FREDERICK COUNTY HISTORIC PRESERVATION COMMISSION

STAFF REPORT

Case No.: COA 24-10 **Staff:** Beau Lockard

Request: Replace the existing vinyl windows with wooden windows, replace the existing vinyl siding with wood siding, and change the fenestration pattern of the façade of the Hoke House.

Image 2: Hoke House, 1932. Shows off-center door fenestration pattern

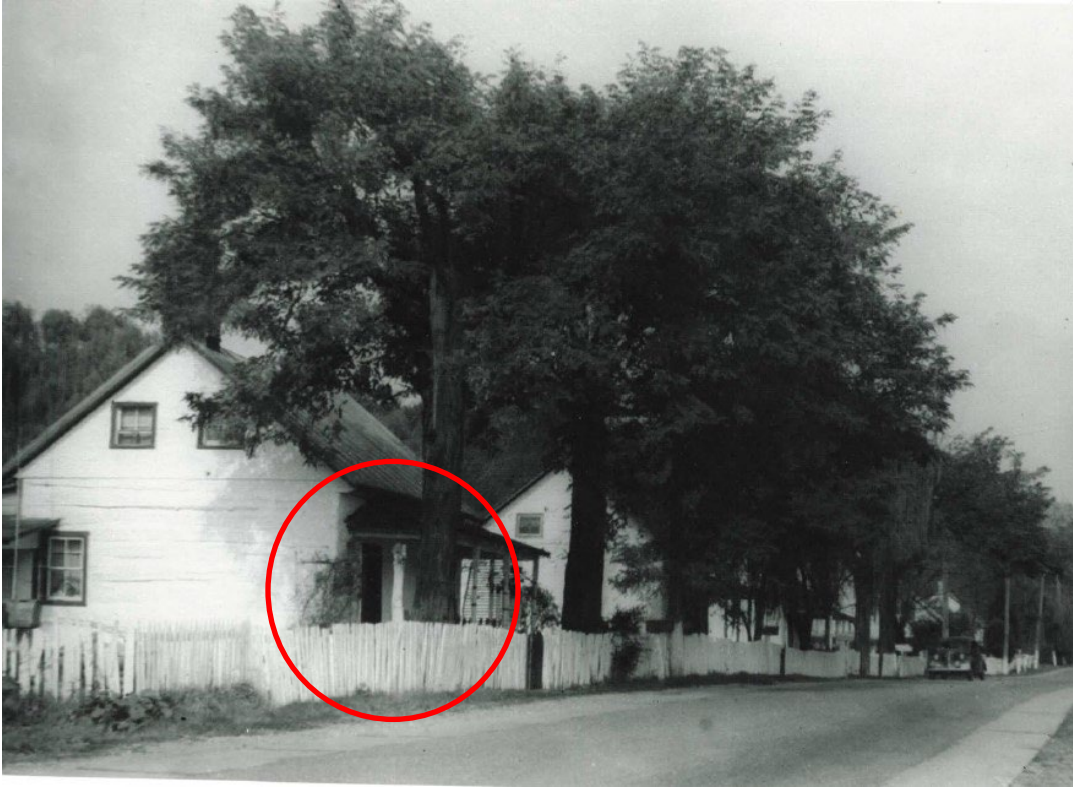
The historic fenestration pattern, partially visible in the early 20th century images (Image 2) provided by the applicant, was changed ca 1940s to center the door in the façade. The applicant is using historic documentation of the Hoke House and similar buildings in the Catoctin Furnace Historic NR District (Images 4 and 5) to inform how the fenestration pattern can be return to its period of significance.
